UNITED STATES PATENT AND TRADEMARK OFFICE

APPLICATION NO.	FILING DATE	FIRST NAMED INVENTOR	ATTORNEY DOCKET NO.	CONFIRMATION NO.
10/679,019	09/30/2003	Keng Shui Wu	UCIP408	1518

DATE MAILED: 03/28/2006

DETAILED ACTION

Fig. 1 is a view in elevation of a fastener embodying my improvements and showing the locking projection continuous in a spiral arrangement in the direction of the screw threads and at an angle thereto.

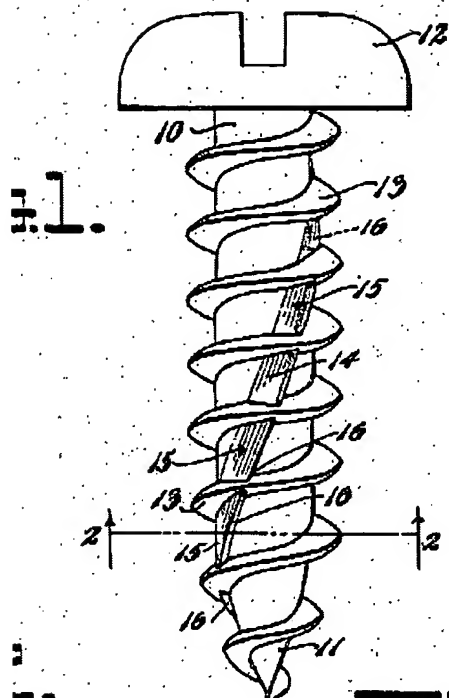
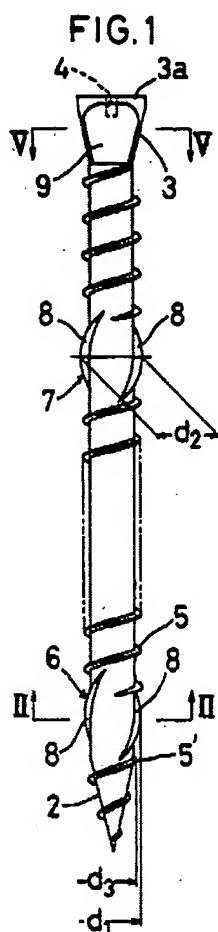
As noted above, Oestereicher teaches a screw with a head having a central recess (head 12 clearly has slot), a shank of a "proper" length (any length is proper for something) and screwing threads (13) and cutting threads (14/15), each of said screwing and cutting threads respectively having different guiding angles (fig 1 above, note claim objection above) and both threads having the same helical direction (above) and extending upward from a lower cone-shaped end portion to an upper end a "little lower" (relative term interpreted very broadly - little lower is relative) from said head, each of said screwing and cutting threads forming an angle phi (see ***Claim Rejections - 35 USC § 112 above***) --note that an angle phi is formed with respect to some {unnamed} line or plane. Note that any helical threads are considered to inherently perform some degree of screwing and cutting.

Re claim 3: As noted above, Oestereicher teaches a screw with a head (head 12), a shank extending from said head, said shank having a screwing thread (13) and cutting thread (14/15), both of said screwing and cutting threads respectively having different 1st and 2nd respective guiding angles (fig 1 above, note claim objection above) and both threads having the same helical direction.

Re claim 4: The screwing thread has a 1st pitch, the cutting thread has a second pitch, and the first pitch is smaller than the second pitch -- see Fig 1 above - the screwing thread 13 is clearly of a smaller pitch than the cutting thread 14/15.
